SEWAGE DISPOSAL SYSTEM

HOWARD COUNTY HEALTH DEPARTMENT

SUBDIVISION West Friendship Estates LOT 27 ROAD 3156 River Valley Chase

**Approved Septic System Plan
Howard County Health Department**

INDICATE NORTH - NAME ADJOINING ROADWAY AS BASE LINE

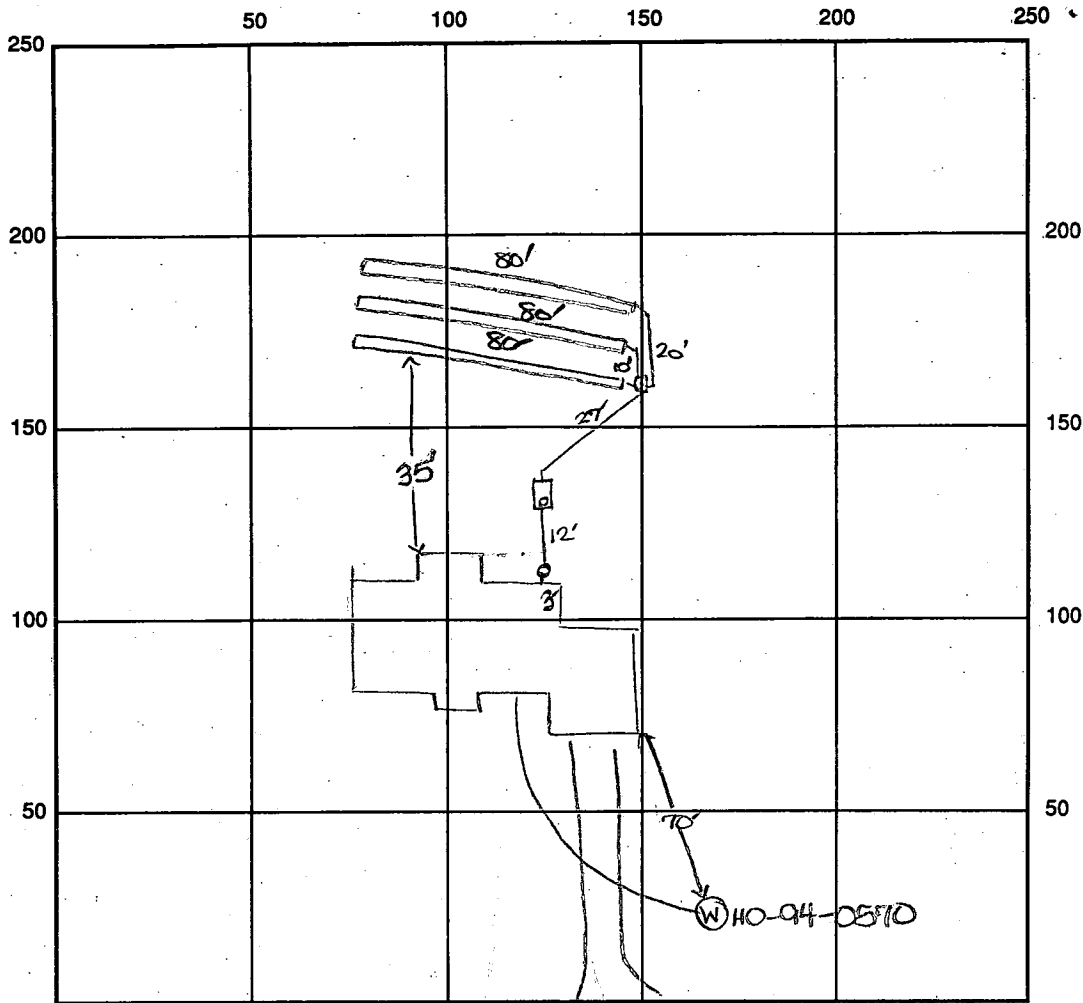
REMARKS: 4-25-97 P.A. 4' below grade, casing 2' above grade, needs 2 piece

water tight cap, WPI ok to cover well line 10m

4-25-97 FINAL INSP - OK TO COVER ALL WORK. DKS

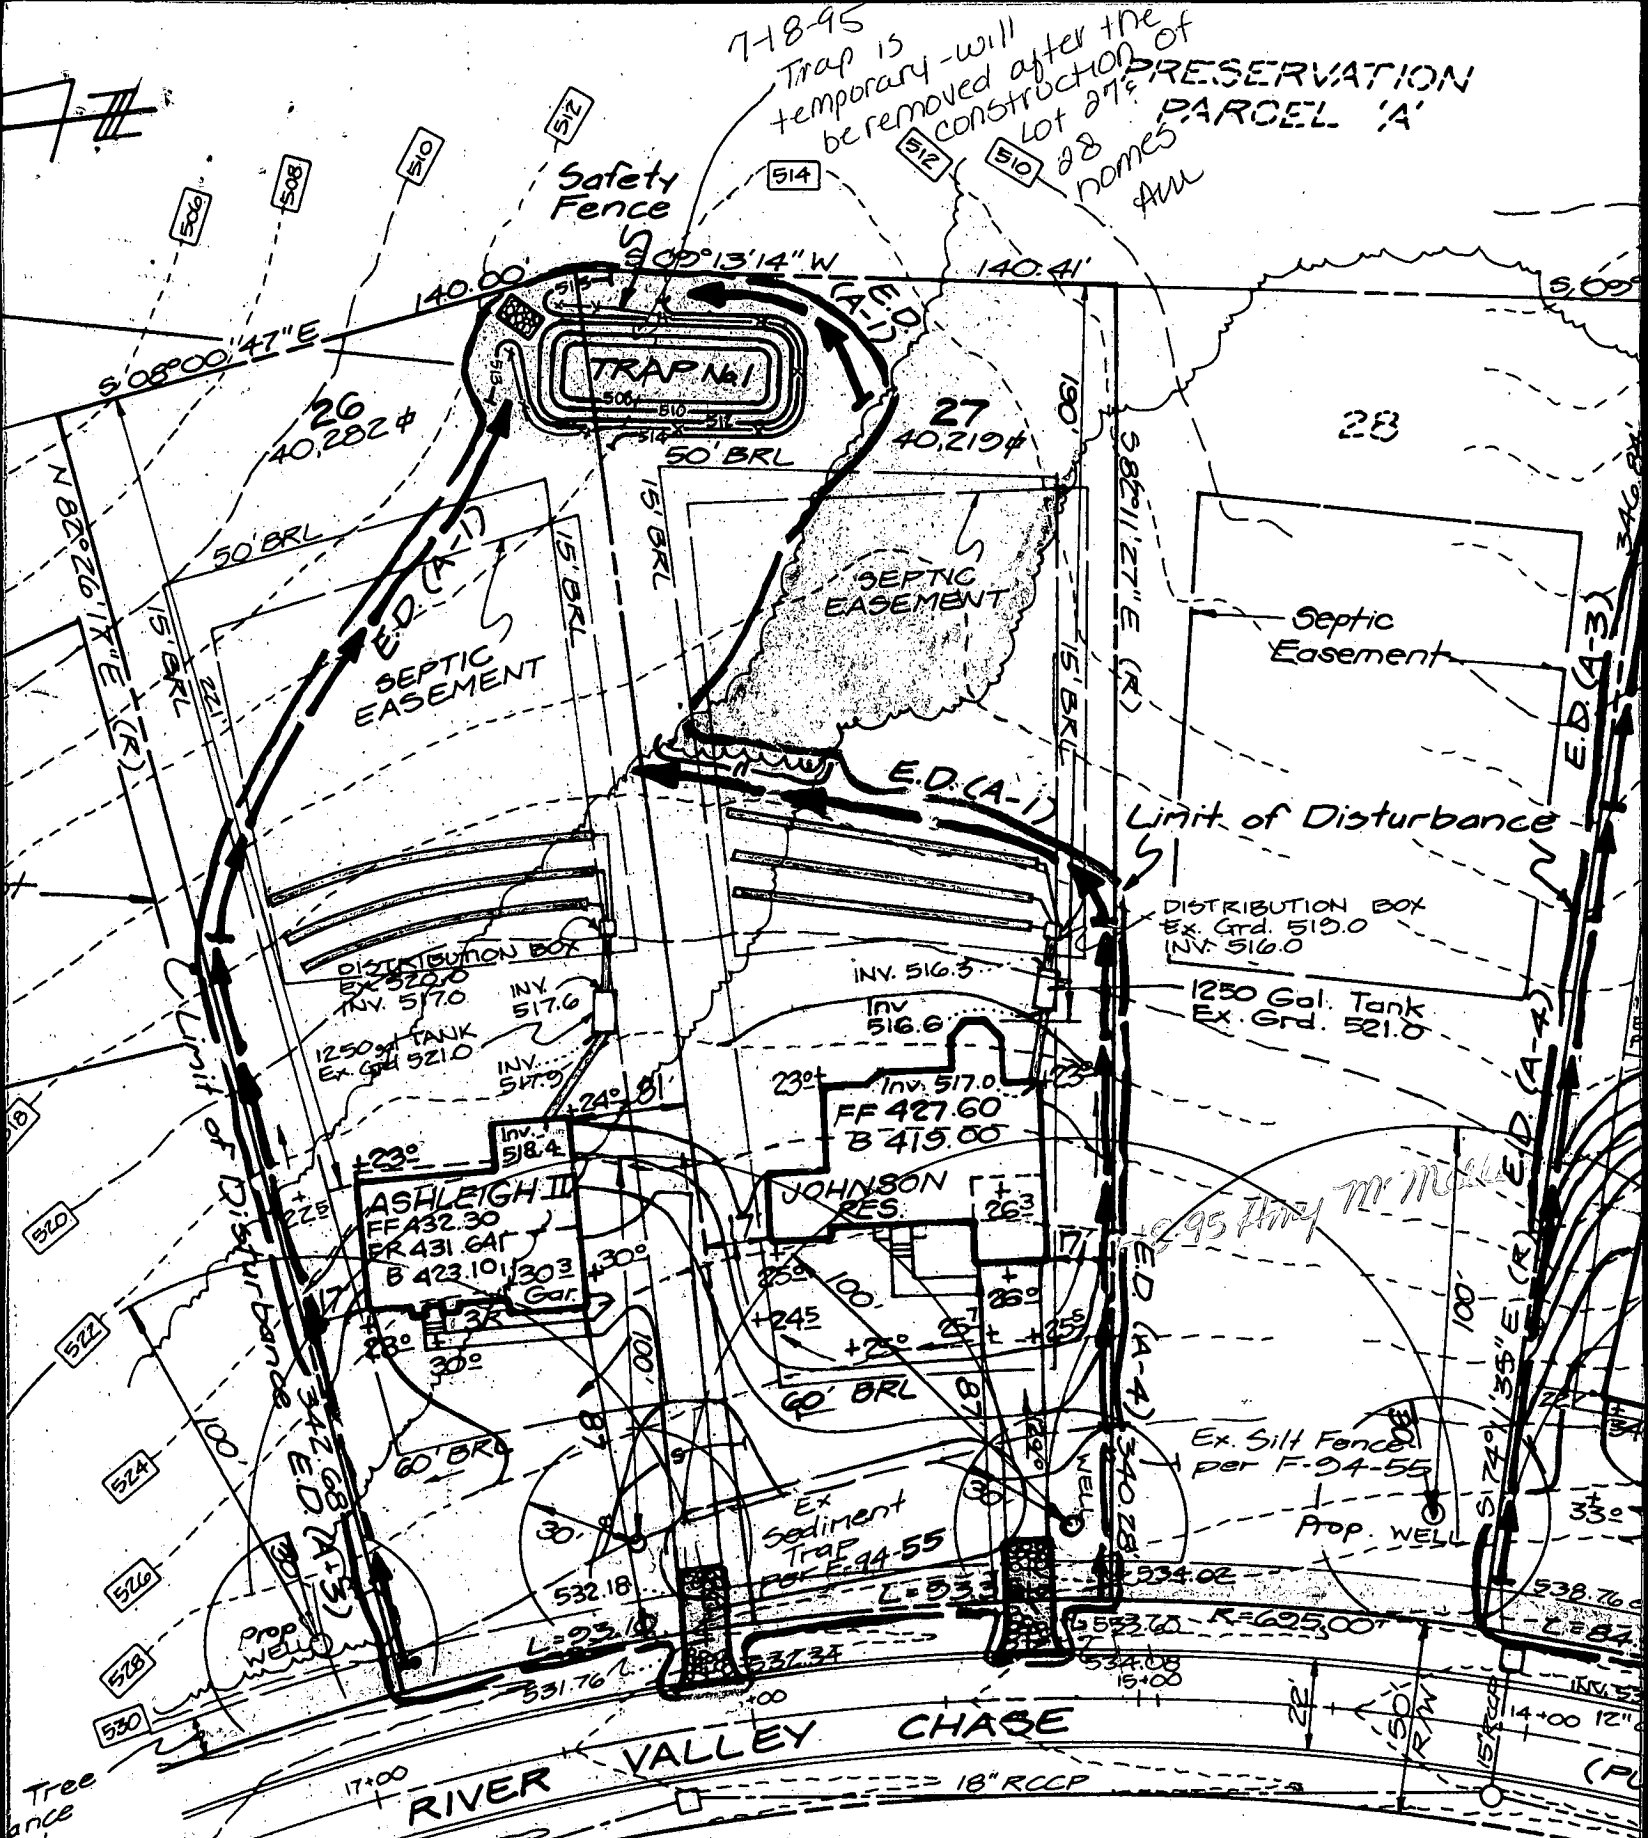
11/7/97
proposed porch will
have no impact on well
and septic as shown.
KM

- Length of trench to be determined at time of septic permit issuance
- manhole cleanout required if >3' cover over septic tank

16 x 16
Porch

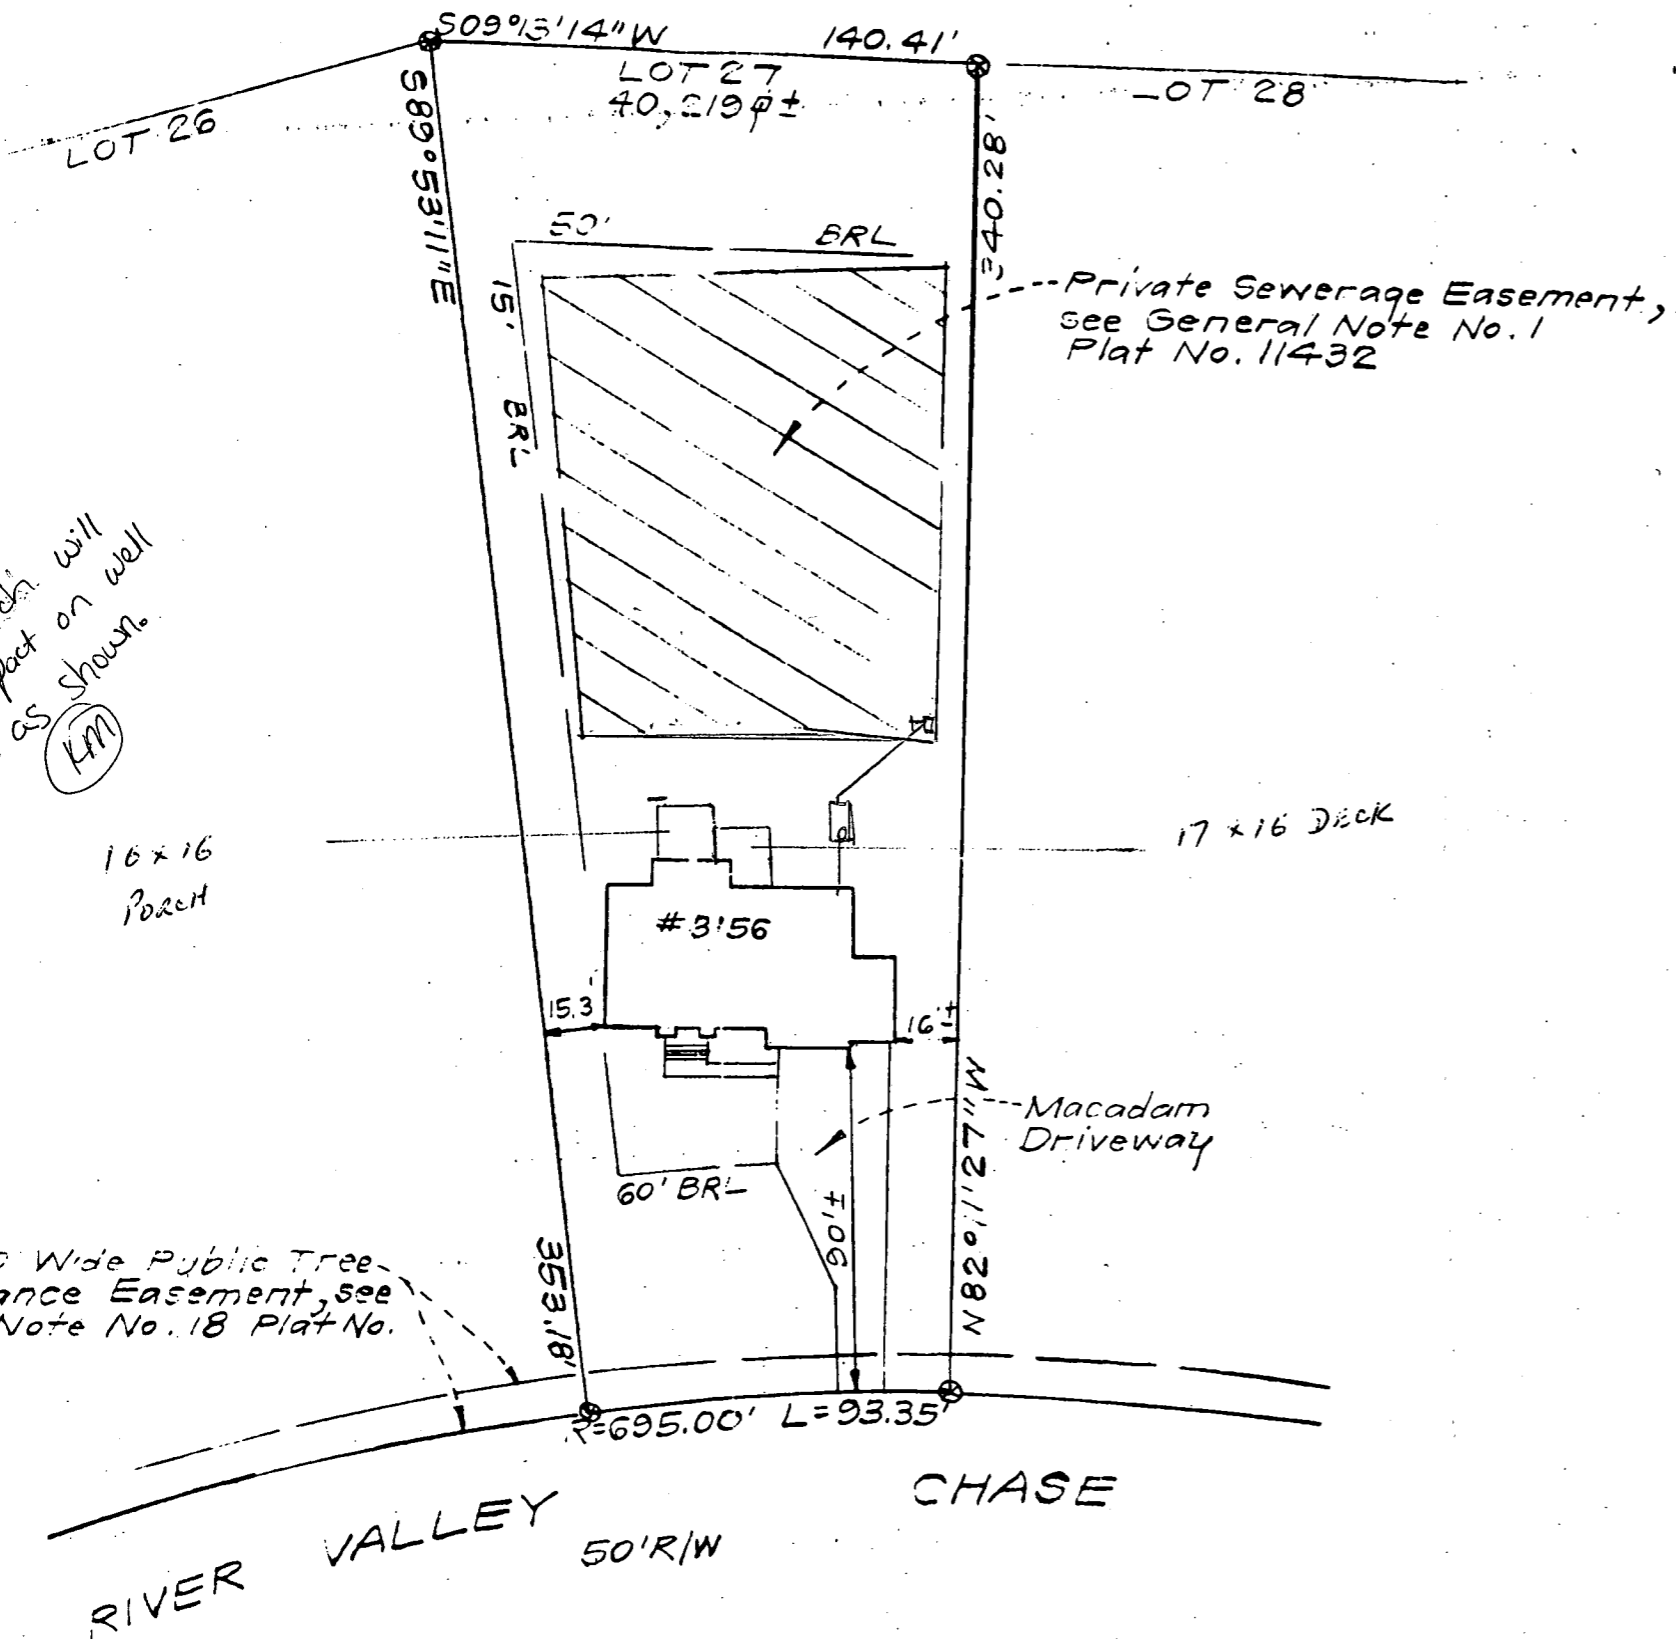
NOTE: BASEMENT DOES NOT SEWER BY GRAVITY-LOT46

11/7/97
Proposed porch will
have no impact on well
and septic as shown.
(KM)
